The Heritage Archives Network of Israel Project

Response to Questions and Clarifications

The National Library of Israel is publishing a response to the questions and requests for clarifications received by qualified parties in connection with the Invitation to Tender for Archive Management System.

Interfacing with ExLibris Rosetta – General Architecture

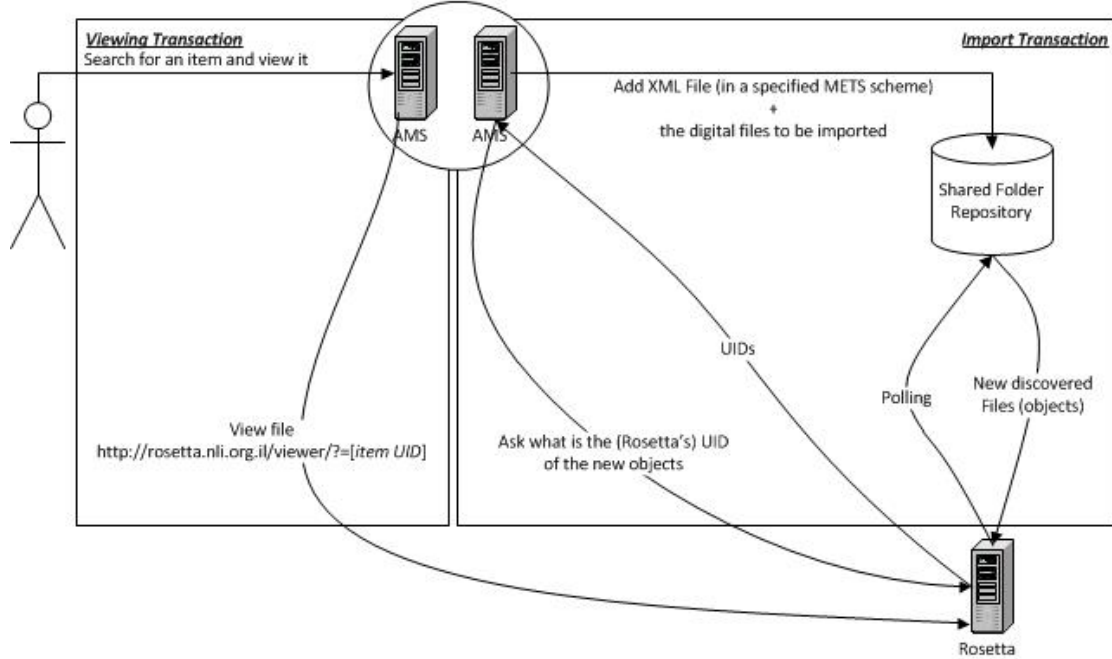
- a. Please provide technical details or documentation on Rosetta's API's.

Further technical clarification of the connection with ExLibris Rosetta is as follows:

Rosetta's API is minor, please refer to the high level interface scheme attached. The AMS will generate an XML METS file (according to a specific scheme that will be provided to the contractor at the start of the implementation phase), that will be deposited in a predefined shared folder repository along with the related digital files. The procedure for ID exchange between the AMS and Rosetta will require development by the contractor and may require access to a specific API that will be provided at the start of the implementation phase (see diagram in appendix 1).
